**Correspondence Between
Staff and Applicant
Approval Letter**

RE: DRB/PRELIMINARY PLAT APPROVAL NOTIFICATION

Case Reference No: 10-PP-2017 118th & Jomax

Re: 118th & Jomax – Case No.: 10-PP-2017
Second Review Comments Drainage

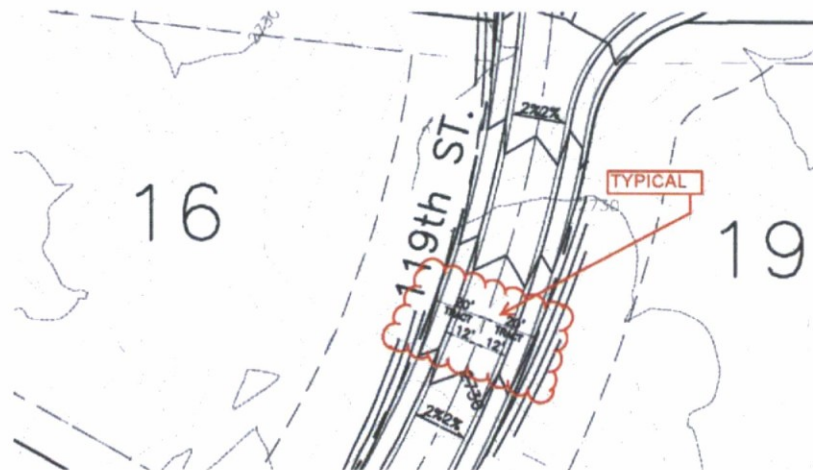
Comment #2: *Please note, this is the 1st review of preliminary grading and drainage plans. It is also first review of preliminary drainage report exhibits and figures. This information was missing in 1st submittal.*

Noted.

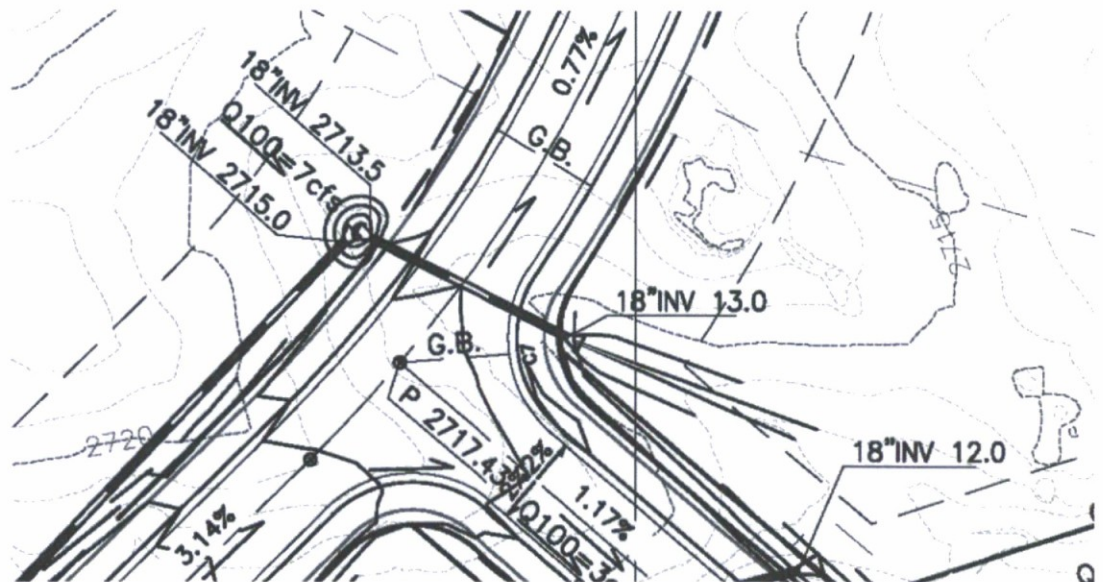
Comment #3: *Preliminary G&D plans lack level of detail expected for a 90% design. Please see and add details identified on the preliminary grading and drainage plan submittal:*

- SHOW AND LABEL ROW
- SHOW AND CALL OUT NAOS
- CALL OUT PROPOSED PIPE SIZES
- DEPICT AND CALL OUT ALL DRAINAGE EASEMENTS, INUNDATION AND LATERAL EROSION SETBACK LIMITS.
- AT BOUNDARY OF SUBJECT PROPERTY DEVELOPMENT WATER WAY CONCENTRATION POINT LOCATIONS CALL OUT POST CONDITION FLOWS OF 2, 10, 100 YFS AND EXIST. CONDITION FLOWS 2, 10, 100 YFS.
- ADD TO LEGEND AND DEPICT ON THIS PLAN ALL FLOW PATHS.
- LABEL STOR 3. IDENTIFY LIMITS OF ALL LAKES CALL OUT HWL, FOT, Q_{100} AND V_0
- SHOW WATER AND SEWER LINES.
- ALL PROPOSED PIPES SHALL HAVE Q_{100} DEPICTED ON THE PLANS.

- ROW 'was' shown with dimensions:
